UNITED STATES PATENT AND TRADEMARK OFFICE

Office Action Summary	Application No. 10/674,198	Applicant(s) CLINCH ET AL.	
	Examiner Katherine W. Mitchell	Art Unit 3677

DETAILED ACTION

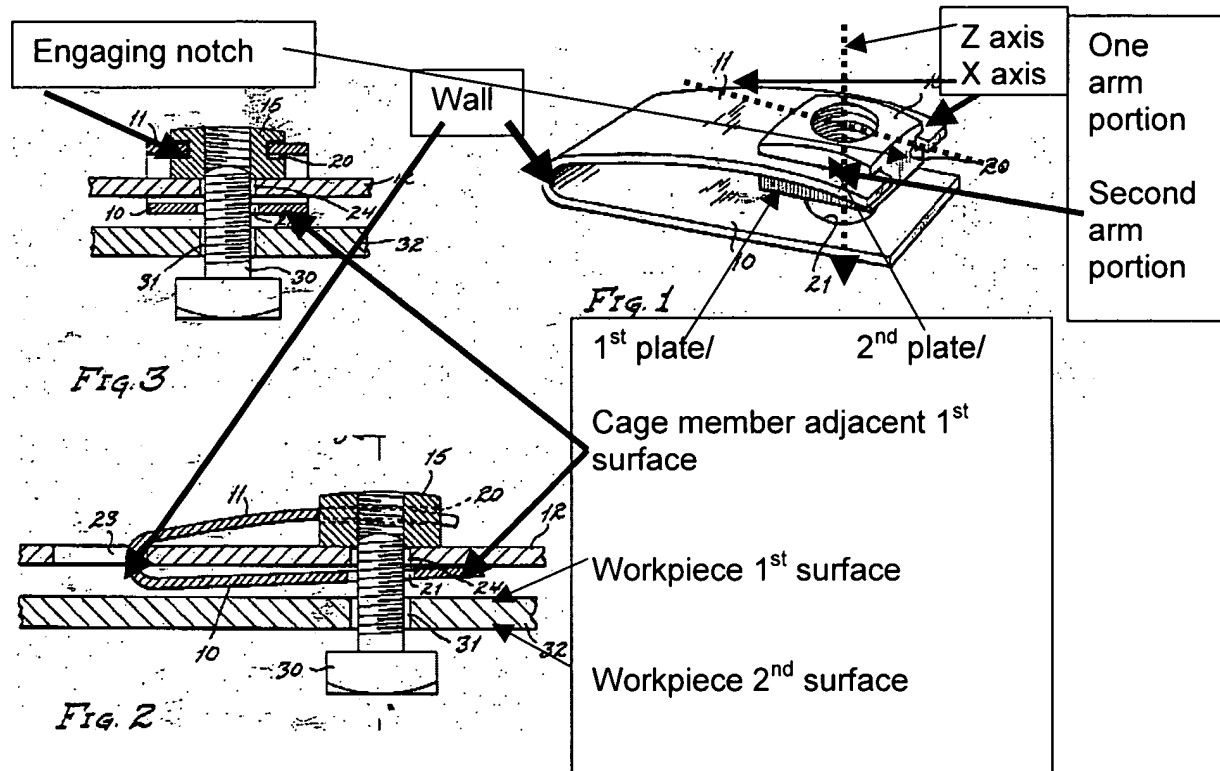
Re claims 1-3, 5-7, 10,11,12,19, 22, 24,26,28,29, 30, 32-35, 37-42 and 48:
Tinnerman 342 in Figs 1-3 teaches a cage member and nut assembly, said nut (15) having a 1st and 2nd portion (see marked up drawings below) enclosed by a cage member (10/11) which has a body configured to engage the nut member such that the nut member is encaged. The cage further comprises a body (11/10), and "11" is considered the upper cage/arm portion, and "10" is the base. The wall is labeled by examiner in drawings below. The nut engagement is such that the 2nd portion (same as

the portion labeled "1st plate" below - looking at the drawings as oriented, it is the "lower" part of nut below "11") of the nut does not come into contact with either the base or the wall. Figs 1 and 3 shows a limited range of motion in at least two dimensions. The body provides a limited range of nut movement in at least two dimensions (axially along what could be called the bolt axis or z-axis is one dimension of limited movement, the plane perpendicular to this, in the x-axis approximately on the surface of "11" -- see dotted lines added to figure 1 below). Examiner notes that the movement in the x dimension is very limited, but movement is allowed while the nut is still encaged.

Further Re claims 3 and 12: As shown in Fig 1, arm portion 11 forms two arm portions at the end as labeled by examiner in drawings below. These two arms are opposite each other.

Further re claims 5-6: The arms are opposite each other and form an opening sized to receive the nut. The size is constant when the nut is encaged or not encaged. Each arm can be considered generally C shaped - the arms together form a C, and thus they are considered to each have a generally c-shaped portion (half of a C). These C-shaped portion are opposite each other and define said opening.

Further Re claims 26, 28 and 48: Fig 1 and 3 show said nut with 1st plate and 2nd plate and a connecting member between said plates, each plate having an upper and lower surface, with aperture therethrough. The upper portion of cage comprises at least one arm extending from said base with said arm having an upper surface in contact with said lower surface of nut second plate (see marked up figures)

Further Re claim 32,37: The body further comprises at least one wall (see label by examiner above), and Figs 1- 3 show the nut engaged such that the nut does not contact at least one wall.

Re claims 52,54: at least part of the arm portions (marked up Fig 1) are capable of independent movement relative to each other -pliers on the end of each arm could move them independently.
